12-BSTD-1

**COMMENTS OF THE
CALIFORNIA BUILDING INDUSTRY ASSOCIATION
REGARDING THE
PROPOSED 2013 BUILDING ENERGY EFFICIENCY STANDARDS**

March 28, 2012

Cost Effectiveness

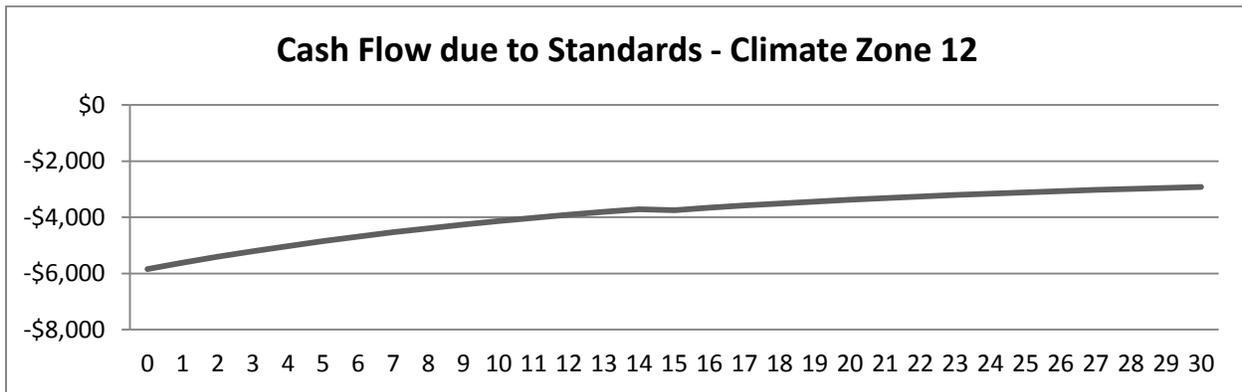
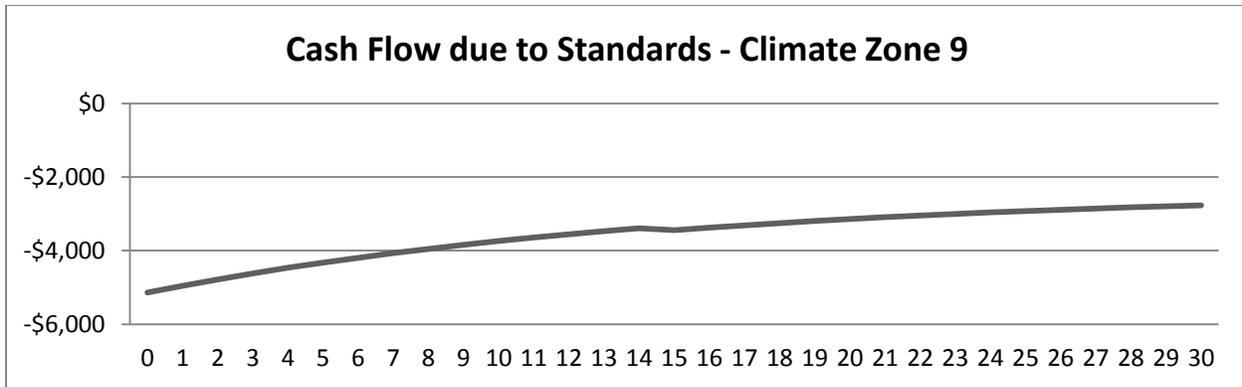
CBIA does not believe that the proposed standards in their entirety are cost effective. The Warren Alquist Act (PRC 25402) requires that the standards “*shall be cost-effective when taken in their entirety and when amortized over the economic life of the structure compared with historic practice*”. CBIA interprets this statute to mean that the entire regulatory package be cost effective over the life of the building as opposed to each individual measure being cost effective. From what we have seen to date, the CEC has only evaluated cost effectiveness in terms of **individual** measures. When the entire package of energy measures is considered, less energy is saved than the sum of energy saved by each measure implemented individually, due to interactions between envelope, heating and cooling, and lighting measures. When evaluated in this way, with a discount rate of 8.3% (consisting of a 2.5% ten year average inflation rate¹ and a 5.9% ten year average mortgage rate²) and energy cost and escalation rates from California Energy Commission’s Annual Energy Outlook 2011³, only one climate zone (CZ 15) will be cost-effective to build to compliance. ConSol’s cash flow analysis used a 30 year life span, with some equipment being replaced at the 15th year. The payback in the only climate zone which ever pays back (CZ15) takes 19 years before the cash flow becomes positive. In the all other climate zones, cash flow does not become positive within the 30 year life of the home. In most cases, at 30 years, the difference in cash flow is from -\$1,000 to -\$3,000. The cash flow analysis for all 16 Climate Zones can be found in an appendix attached to this comment letter. The table and graphs below show examples for Climate Zones 9 and 12
